State of Alaska
Department of Fish and Game
Sportfish Division

Nomination Form
Anadromous Waters Catalog

191-20-13600-2046

CORRECTION

Figure 1.—191-20-13600-2046 route correction map.

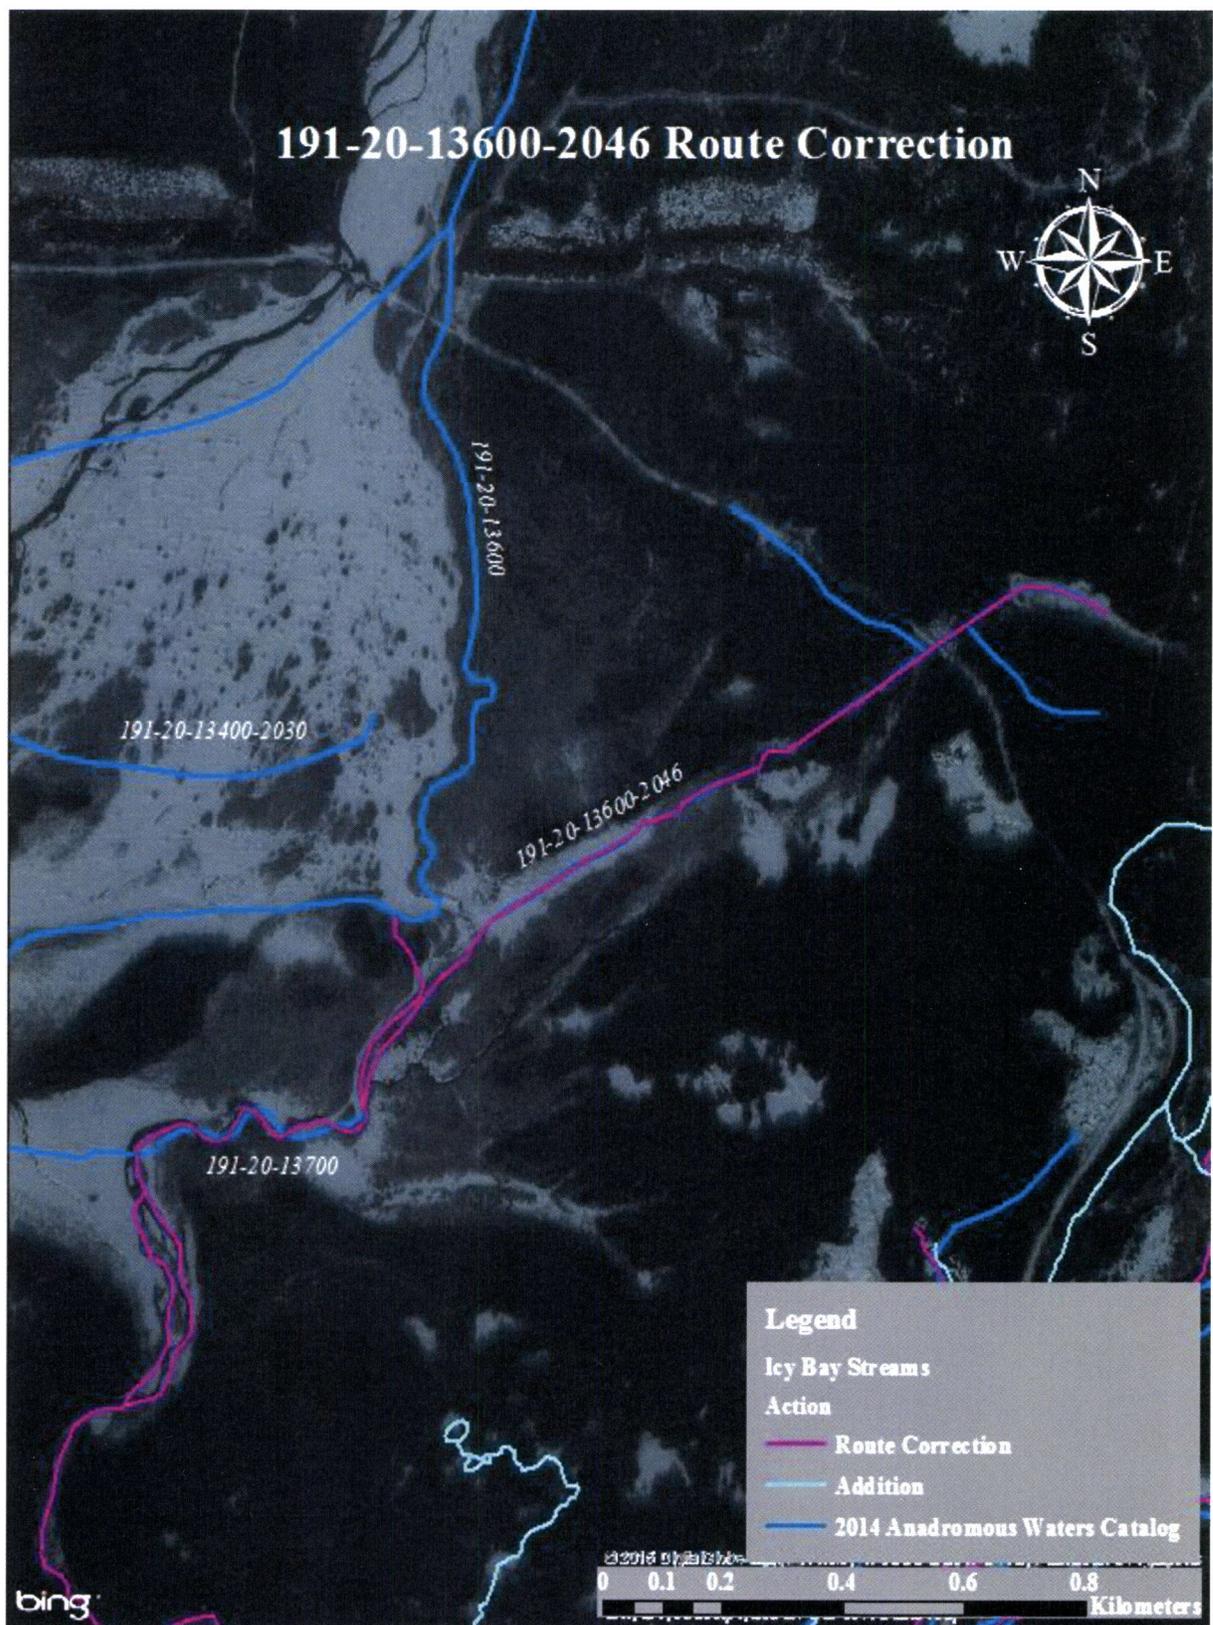
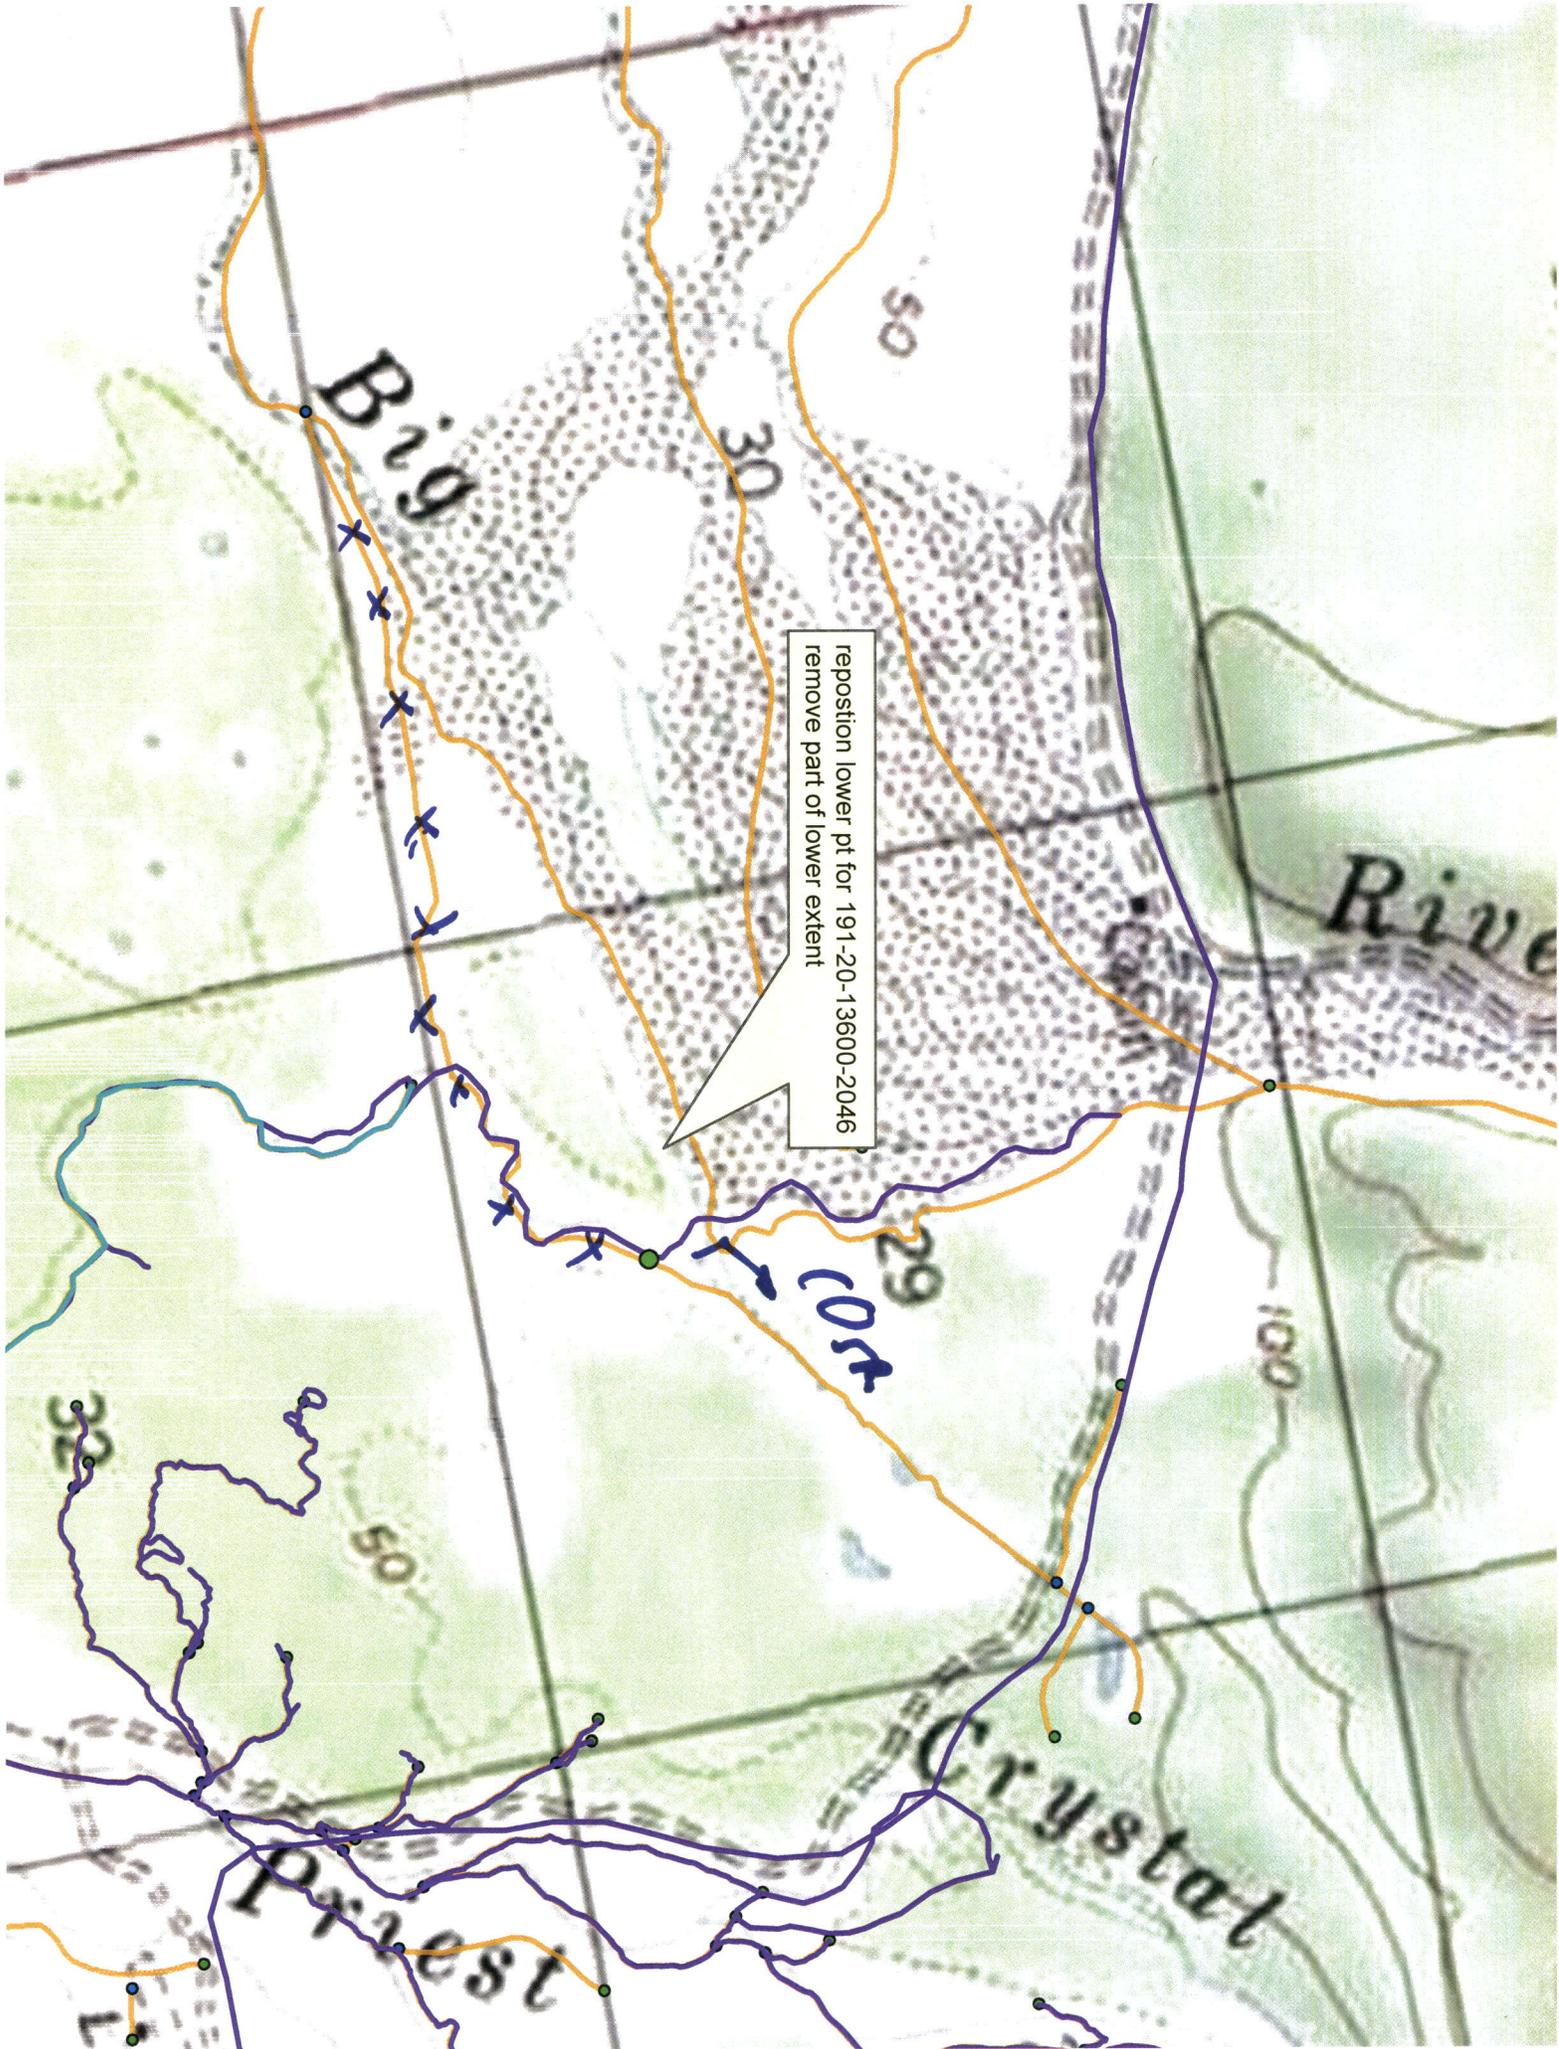
Comments:
 Need to shorten this stream in order to correct Stream No. 191-20-13700 that is in the 2015 update. Could not show the full extent of 191-20-13700 due to 191-20-13600-2046 stream arc being in the way. We did not investigate 191-20-13600-2046 enough to see if stream could be delisted. Coordinates (Lat,Long): Upper(59.9820,-141.694) Lower(59.9740,-141.694)
Move -2046 lower pt and remove portion of creek

Findings: Further investigation is needed to see if this stream still exists or has become seasonal. After two different visits water was not observed in this stream. If stream still exists it would connect with the new braid of the Big River that was thoroughly investigated.

reposition lower pt for 191-20-13600-2046
remove part of lower extent

Recommendations: Shorten the existing stream arc to reflect more likely stream arc in the Anadromous Waters Catalog.
